Re: Edwards Aquifer, Comal County

Name of Project: Oakwood Baptist Church Expansion; Located at 2152 Loop 337; New Braunfels, Texas

Type of Plan: Request for Modification of an Approved Water Pollution Abatement Plan (WPAP); 30 Texas Administrative Code (TAC) Chapter 213 Edwards Aquifer

Re: Edwards Aquifer Protection Program, Comal County
TYPE OF PLAN: Modification to a Water Pollution Abatement Plan
NAME OF PROJECT: Oakwood Baptist Church Youth Center Modification
Response to Technical Review Comments dated June 20, 2012.

PERMANENT WATER POLLUTION ABATEMENT PLAN & DETAILS (PHASE 1)
OAKWOOD BAPTIST CHURCH
NEW BRAUNFELS, TEXAS

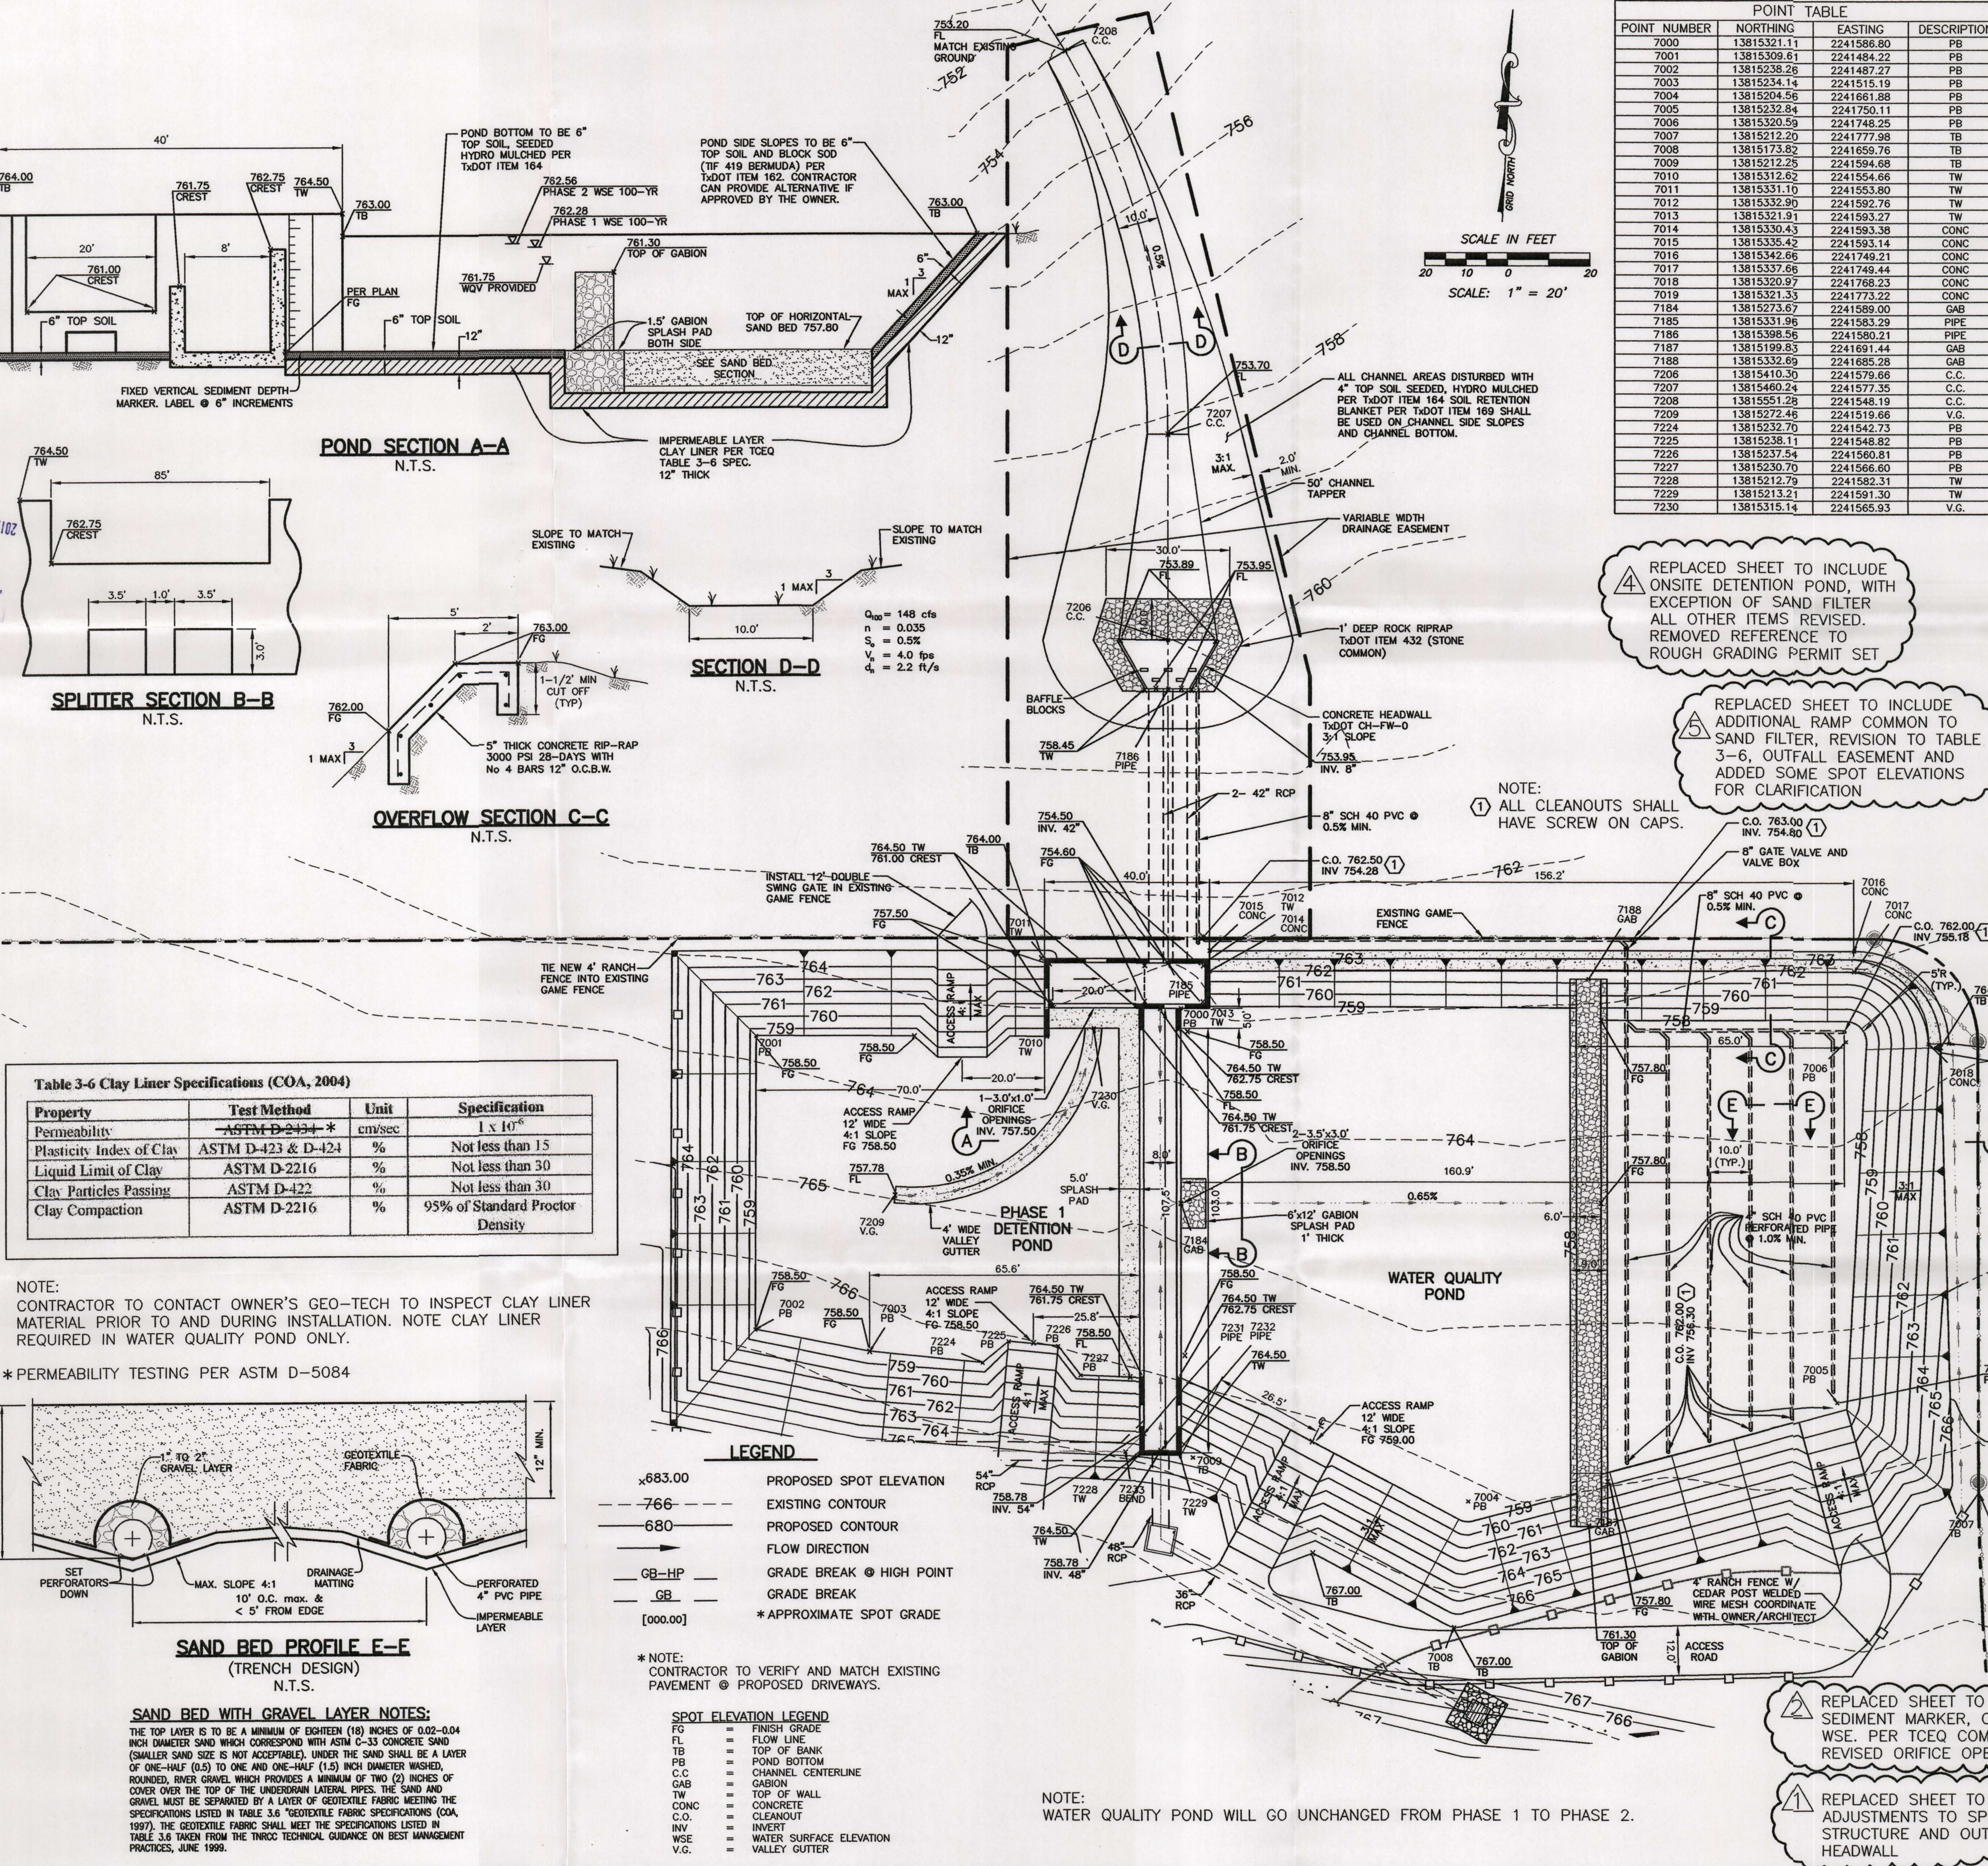
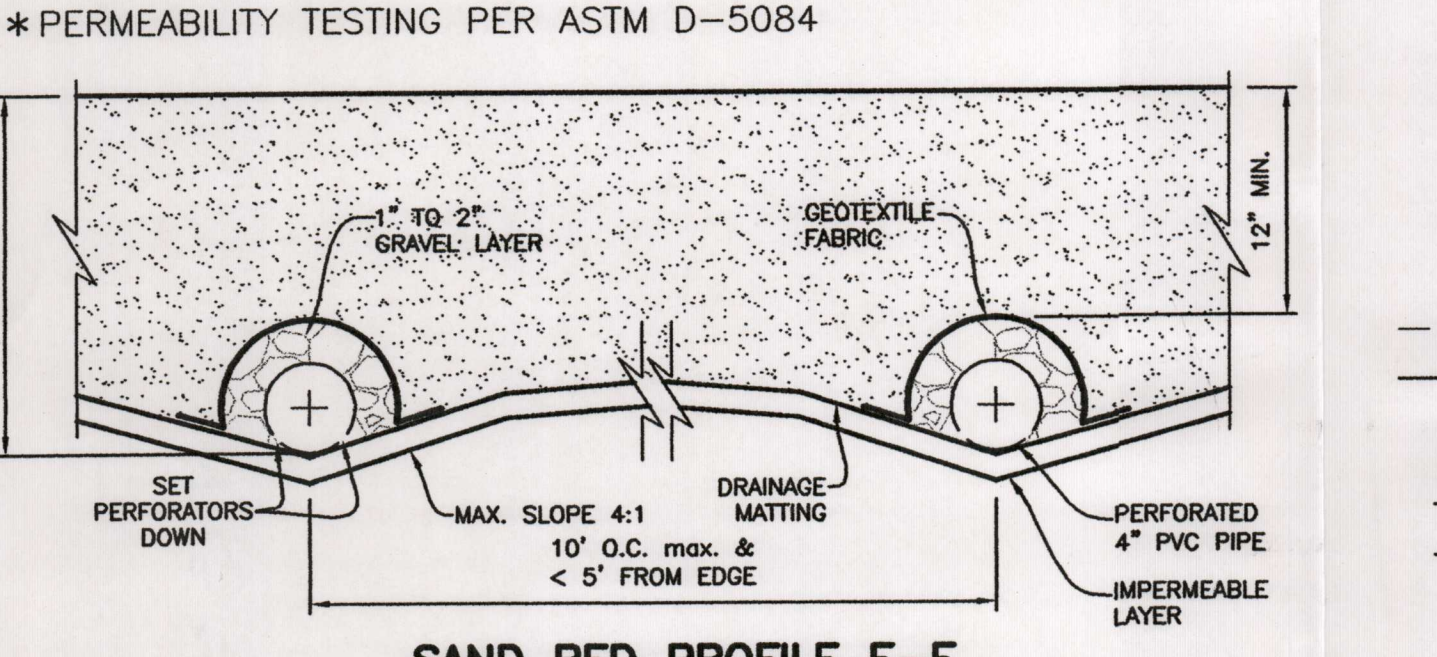
2. Please indicate the location of the basin maintenance staging area.
3. The proposed contours appear to indicate that the uncaptured areas (access drives) may be larger than illustrated, i.e., the northern access drives. Please confirm the boundaries of the uncaptured areas and provide the acreage for each area. Revise the site plan as necessary. If the uncaptured areas are larger than previously reported, please revise the basin sizing calculations and all applicable details as necessary.
4. A service ramp is provided into the sedimentation chamber of the sedimentation/filtration basin but not the filtration chamber. Please explain how access will be gained into the filtration chamber of the basin.

REPLACED SHEET TO INCLUDE ADDITIONAL RAMP COMMON TO SAND FILTER, REVISION TO TABLE 3-6, OUTFALL EASEMENT AND ADDED SOME SPOT ELEVATIONS FOR CLARIFICATION

REPLACED SHEET TO ADD SEDIMENT MARKER, CAPS, AND WSE. PER TCEQ COMMENTS. REVISED ORIFICE OPENINGS

The WQP Plan Sheet has been revised to reflect a minor modification to the shape of the pending outfall easement, Table 3.6 of the Clay Liner Specification was edited to include reference to the required permeability test and some additional spot elevations were added to the pond bottom for clarification only.
